# Town of Mammoth Lakes

## Advisory Design Panel Staff Report

<b>Date:</b>	February 14, 2019	<b>File No.:</b>	Major Design Review (DR) 18-006
<b>Place:</b>	Town & County Conference Room, 2 <sup>nd</sup> Floor Minaret Village Shopping Center Mammoth Lakes, CA 93546	<b>Project:</b>	Yotelpad
<b>Time:</b>	After 2:00 p.m.	<b>Location:</b>	6040, 6042, 6060 Minaret Road
<b>Appeal Status:</b>	Not Applicable	<b>General Plan:</b>	North Village Specific Plan (NVSP)
<b>Applicant / Owner:</b>	RePlay Destinations - Chris Heinrich / One Mammoth, LLC	<b>Specific Plan:</b>	North Village Specific Plan (NVSP)
<b>Environmental Review:</b>	Conformance review with the existing North Village Specific Plan Environmental Impact Report	<b>Zoning:</b>	North Village Specific Plan (NVSP)

**TITLE:** Yotelpad Design Review

**SOUTH ELEVATION**

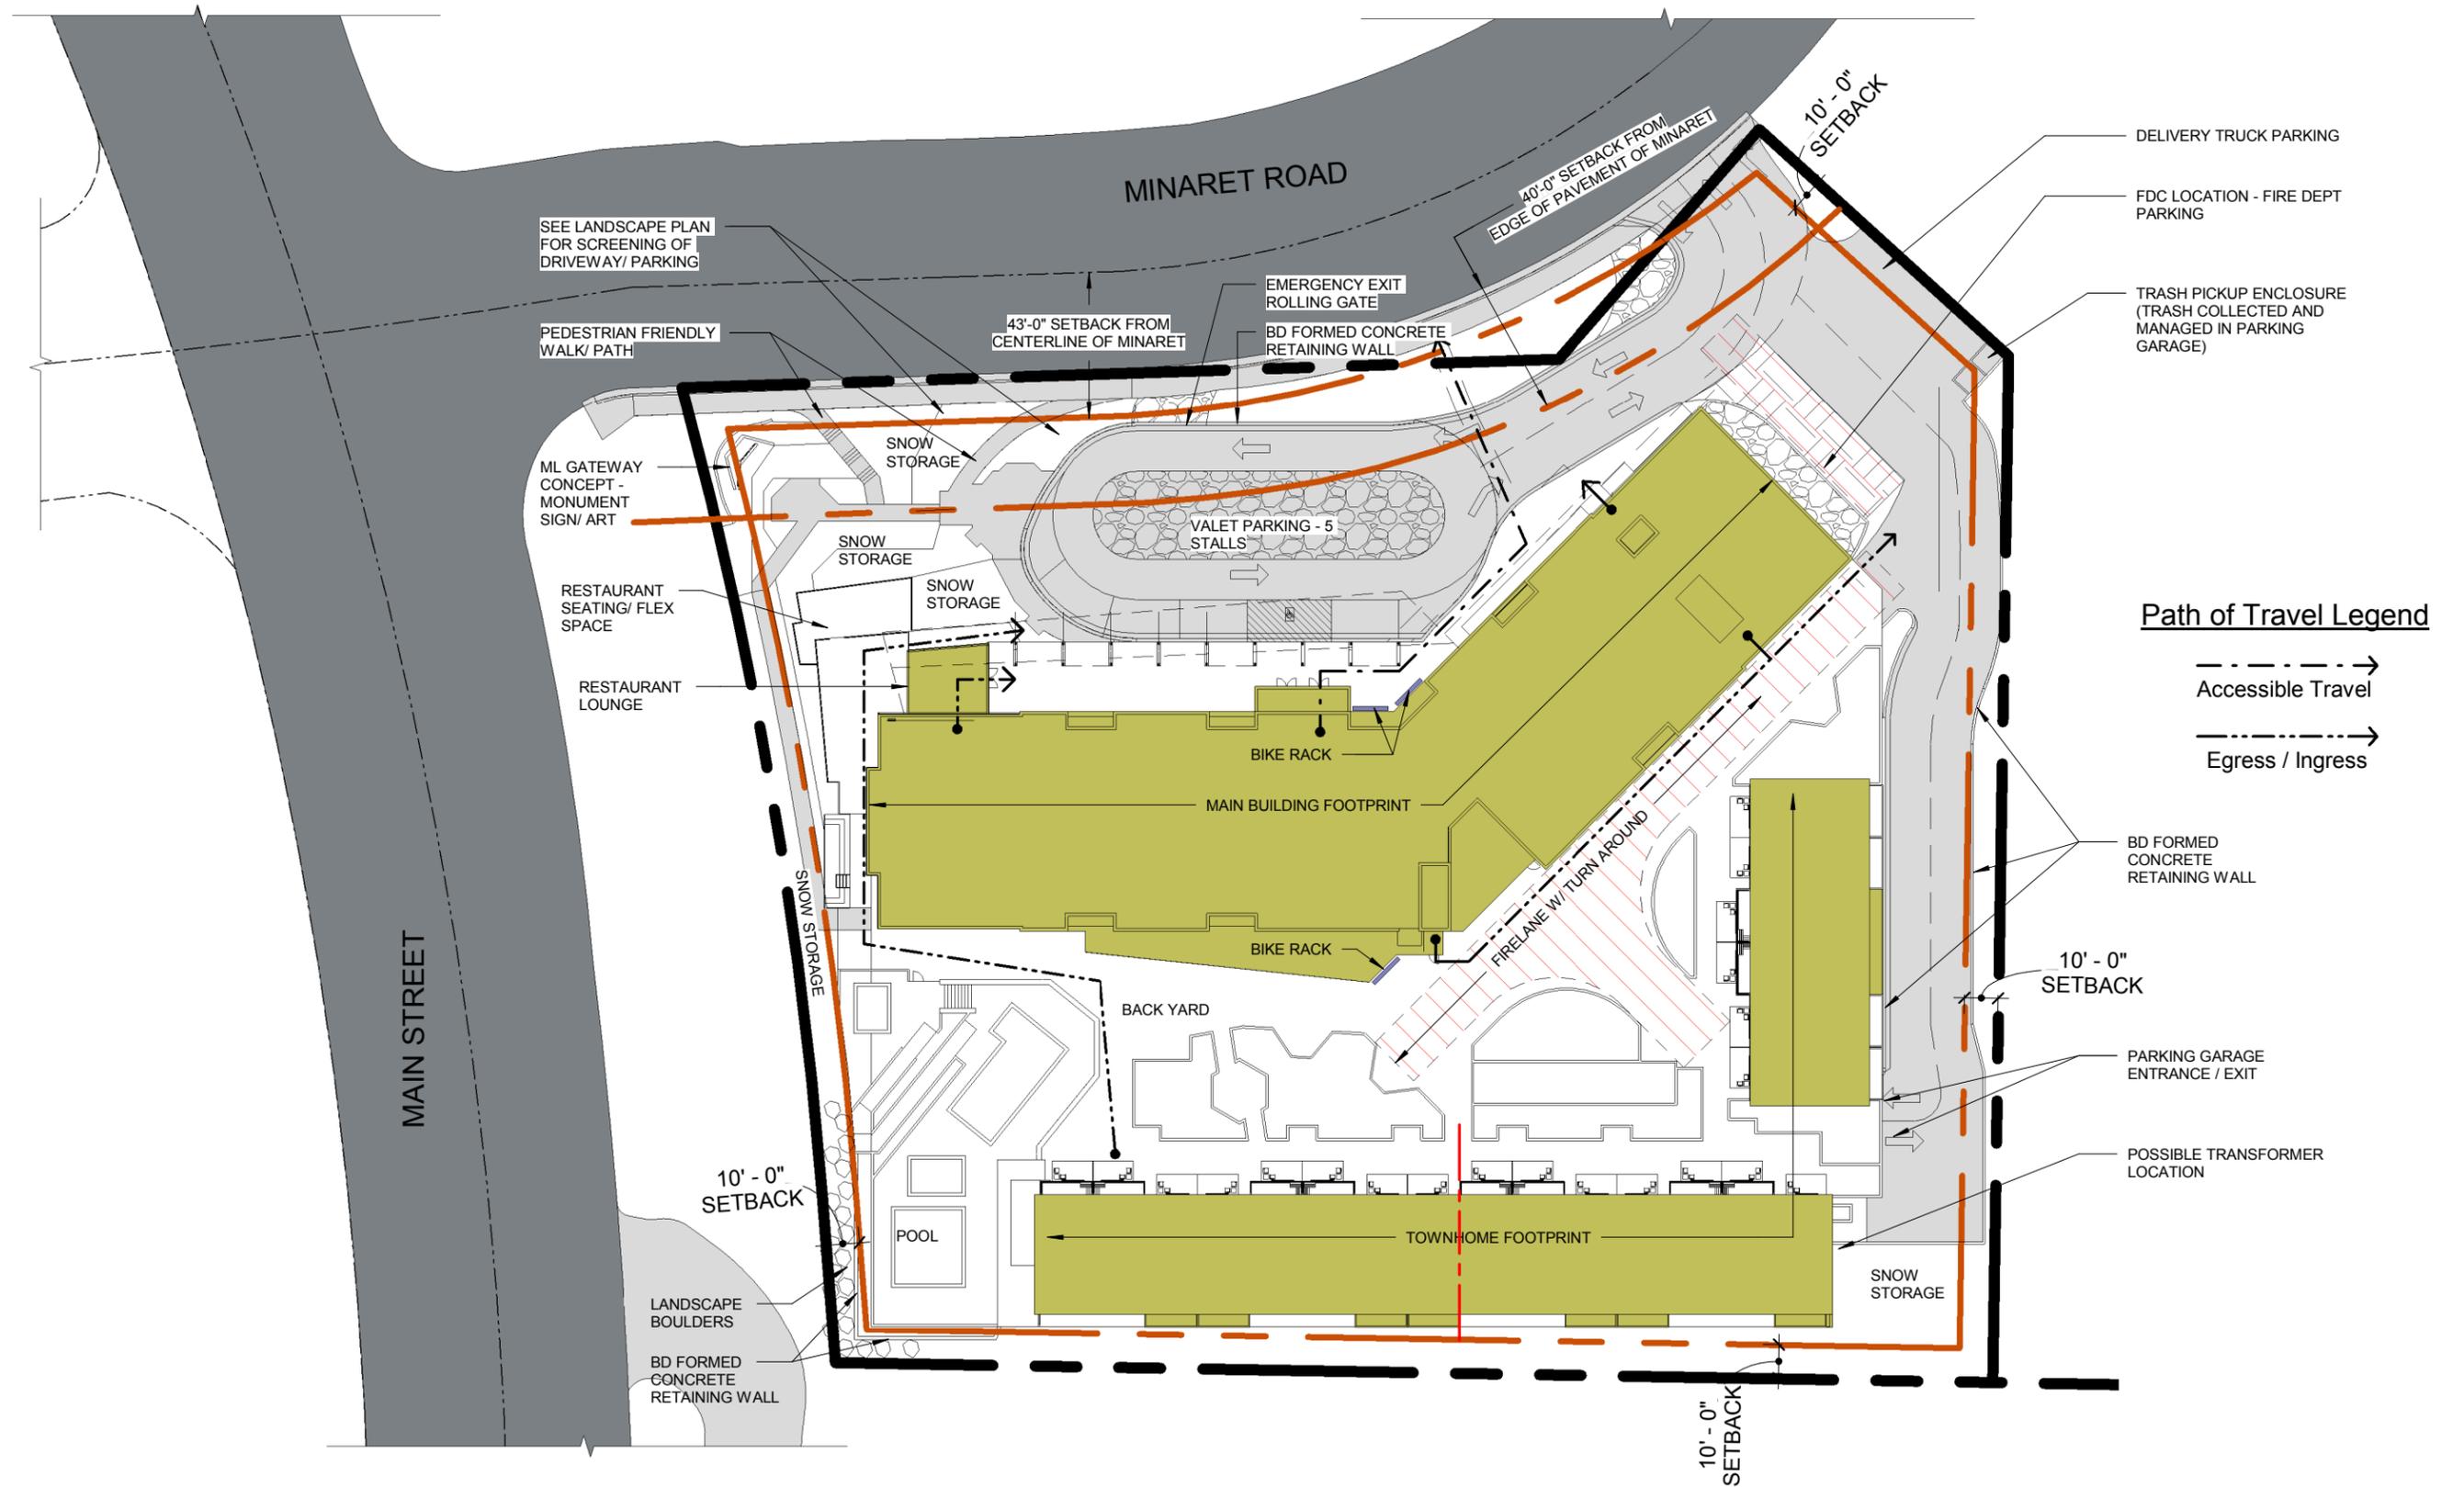
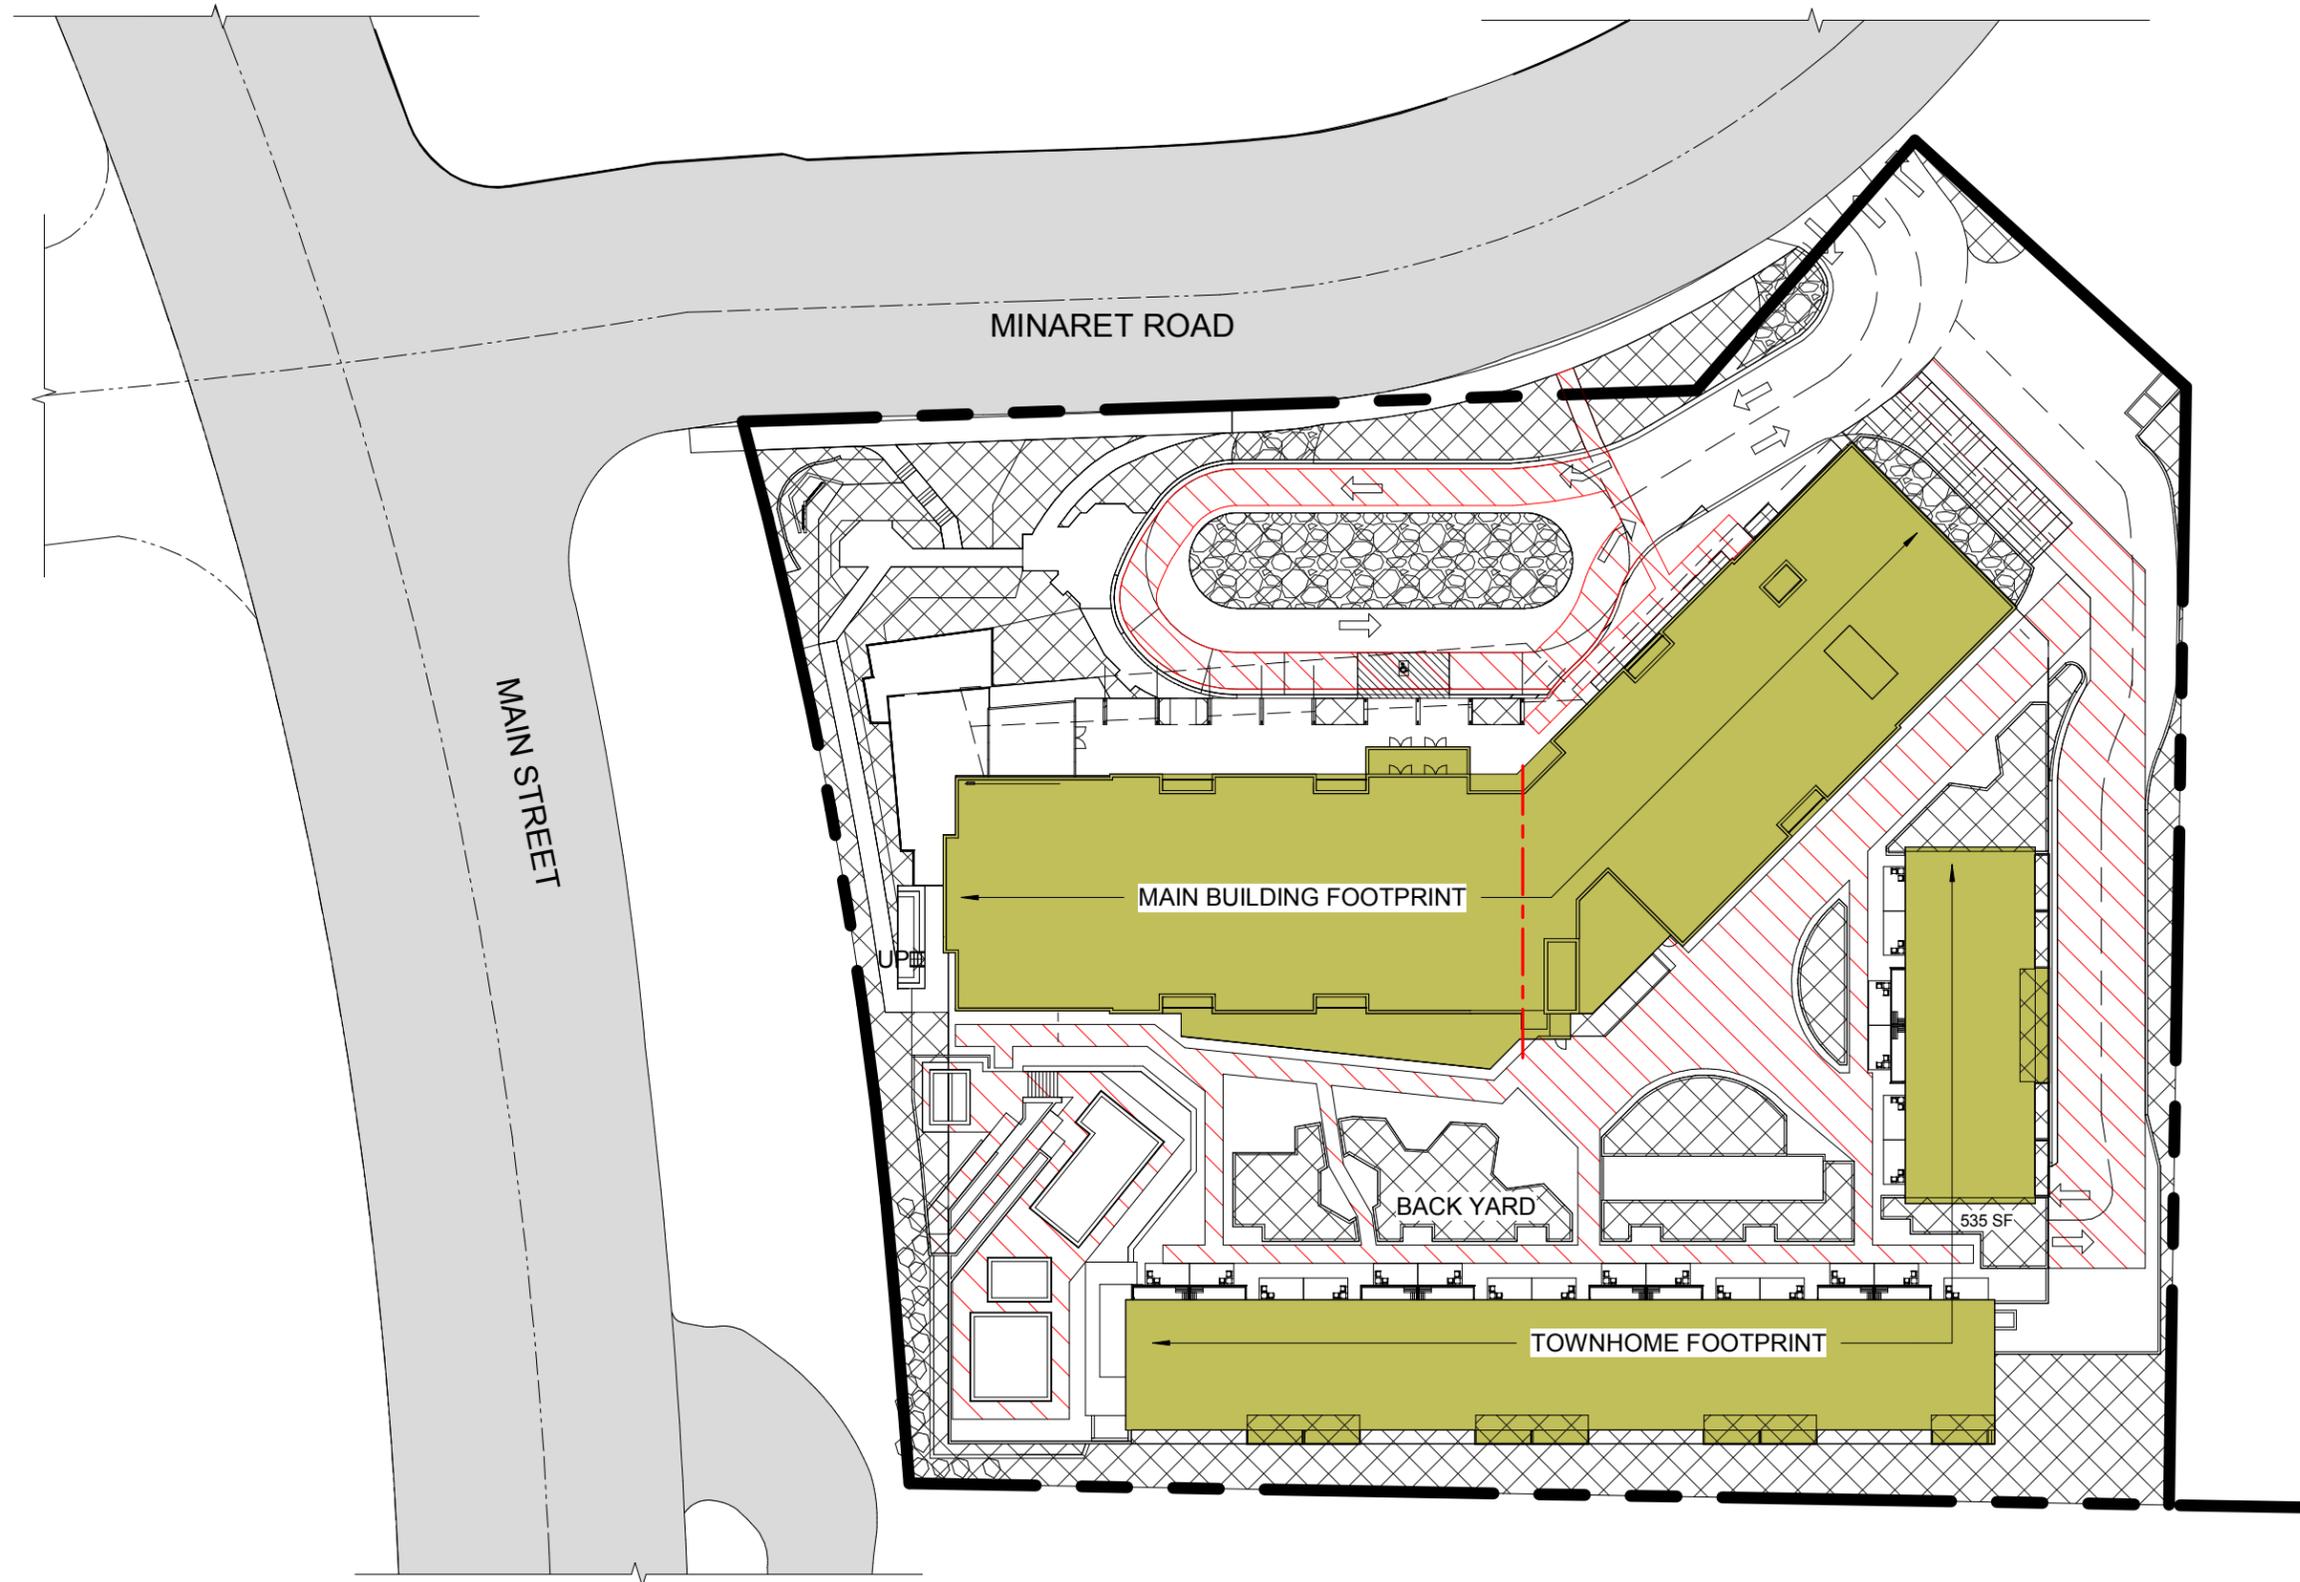
8. The forms and mass of the building are too severe and are not broken up enough. The applicant could consider removing or varying some of the building modules to break up the massing.

11. The roof form is too consistent and needs to be broken up more. This is an issue for both the townhomes and the hotel building.
12. The buildings need a better connection to the ground. This could be achieved with color and material (does not need to be stone) or through the use of a storefront type material/metal.

8. The forms and mass of the building are too severe and are not broken up enough. The applicant could consider removing or varying some of the building modules to break up the massing.

11. The roof form is too consistent and needs to be broken up more. This is an issue for both the townhomes and the hotel building.
  - Response:
    - The proposed exterior massing for the YotelPad project features a parapet wall that steps in-and-out, following the undulations of the floor plan. the roof line of the town homes has been updated to also step to add visual interest along the length of the facade. See the updated exterior elevations provided for reference.

- The massing of the ground floor has been broken up through the following revisions:
  - i. The restaurant footprint has been expanded out towards Minaret Road and includes a redesigned entry/lobby area; and
  - ii. The roof element and porte-cochere is more substantial and has added design elements to break-up the massing.
- The roof line of the hotel structure and the townhomes has been varied to break-up the massing and provide visual interest.
- The colors and materials have been revised to reflect the comments from the ADP. A fiber cement board siding with a wood appearance (western red cedar) is proposed in place of natural wood.
- The amount of stone on the townhomes has been reduced in response to the ADPs comment.

- Response:
    - Additional roof element at level one has been extended further north on the main façade to help break up the massing per the discussion at the first review. See the updated exterior elevations for reference.

**SITE COVERAGE TABLE**

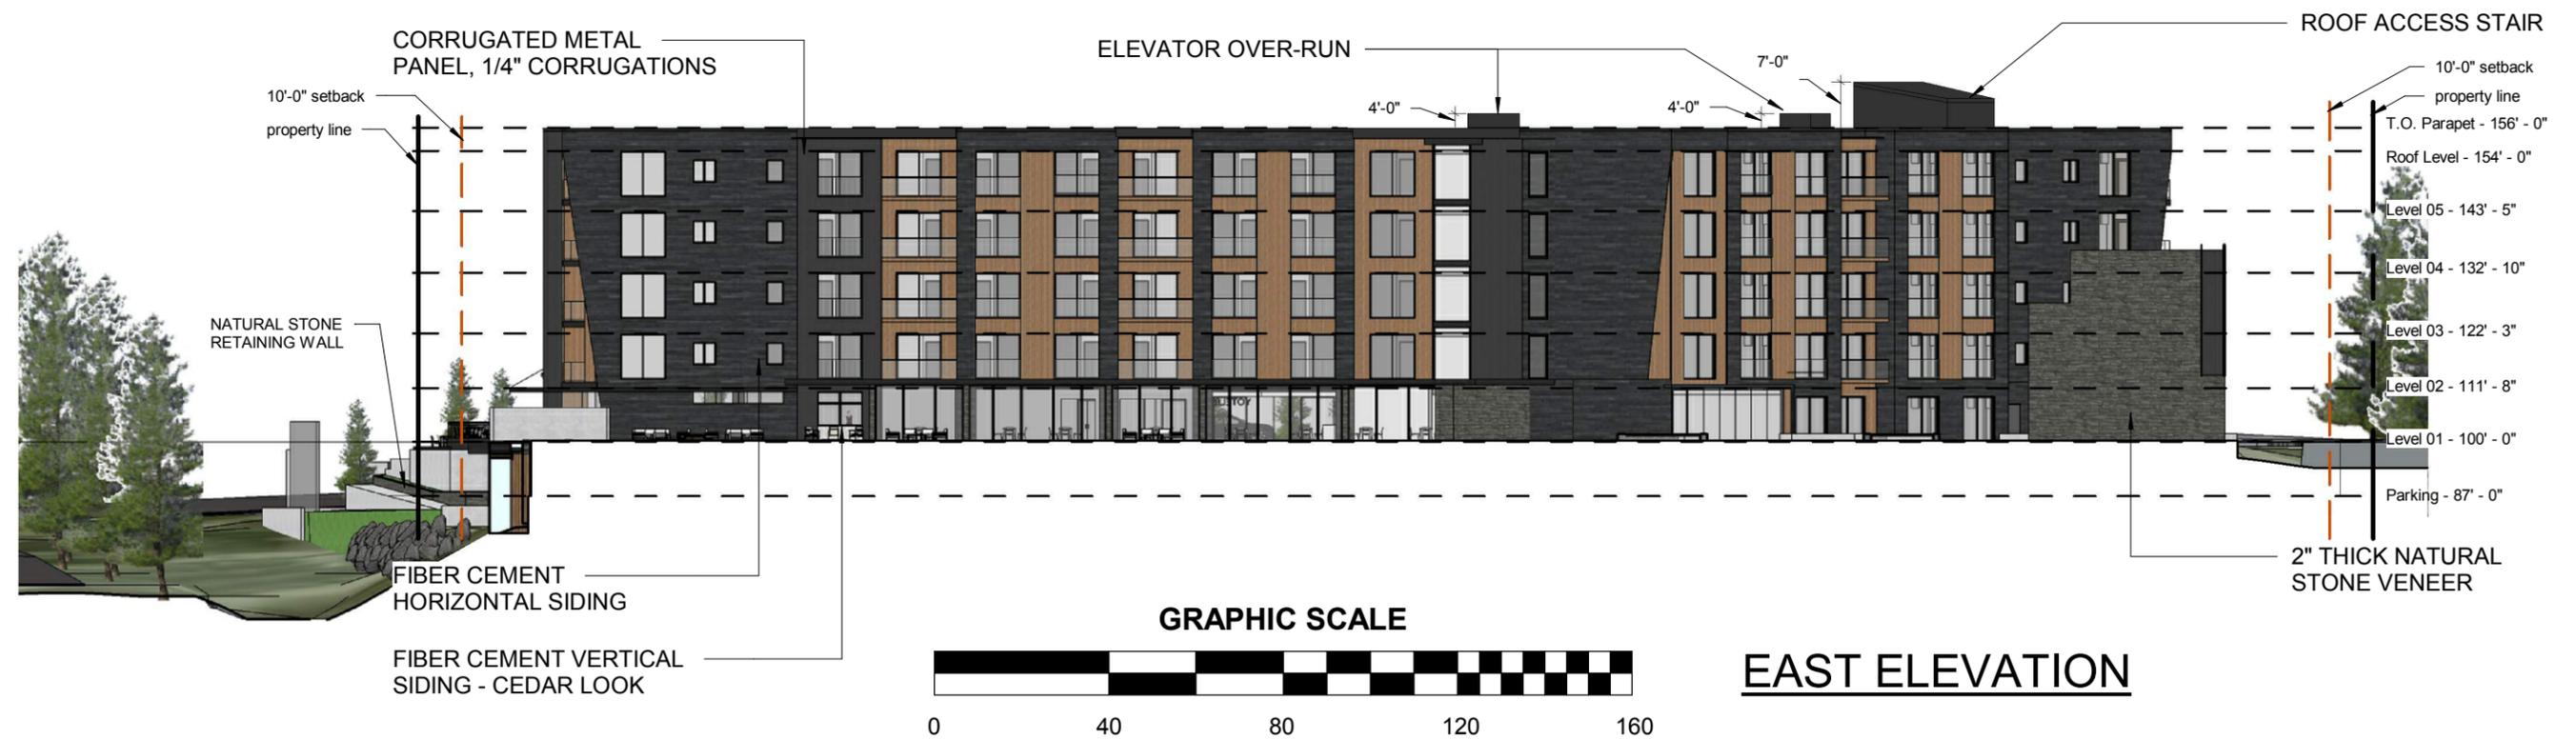
1. Pedestrian circulation is an issue and the project, as designed, is not consistent with the North Village Design Guidelines related to pedestrian connectivity. The front parking area impedes pedestrian connectivity to the Village and the visual of the parking lot and adjacent sidewalk as viewed from Main Street and Minaret Road appears as a “sidewalk in the middle of a freeway.” The pedestrian area on the corner will be limited to summer use only and will be oftentimes windy.
2. The southwest corner of the site is the most visible location in Town and to use it as a parking lot is a loss. Consideration should be given to developing that corner with hotel guest uses (i.e., lobby area or restaurant space) to animate that corner and add visual interest and provide a buffer between the street and the rest of the project.

5. The site design should take advantage of the existing vegetation around the site and preserve as many trees as possible, especially near the southwest corner of the site.

4. The number of surface parking spots should be reduced in order to reduce the size of the parking lot (*Note: a minimum of three check-in parking spots are required*).

- The southwest corner of the site has been redesigned and includes the following items:
  - i. Landscaped terraces that will have a variety of trees, plants, and boulders walls;
  - ii. A gateway monument sign and artwork;
  - iii. An extended restaurant patio space the can be used by the restaurant or the HOA;
  - iv. A restaurant lobby/entrance area that is extended from the main building;
  - v. An extended viewing platform providing views to the south;
  - vi. Improved pedestrian pathways; and

- vii. A reduced surface parking area.
- The number of surface parking spots was reduced to five guest check-on spots.
- Additional landscaping is proposed at the southwest corner and along Minaret Road to screen the entry apron (i.e., check-in parking area). Additionally the size of the landscape area between the sidewalk and the entry apron has been increased to provide greater separation.
- The parking garage wall near the southeast corner of the site is proposed to be stepped to reduce the mass of the wall and the lower wall will be constructed out of boulders to provide a more natural transition.
- The design of the entry apron has been revised to accommodate fire truck setup and turning movement requirements. Emergency vehicles will exit onto Minaret Road via a one-way emergency exit. This has been reviewed by Caltrans and the Mammoth Lakes Fire Protection District.

- Response:
    - The arrival valet has been reduced in size and all permanent parking has been eliminated (5 valet stalls). The size of the arrival valet lot was in part dictated by the required Fire Truck turning radius movements and setup.
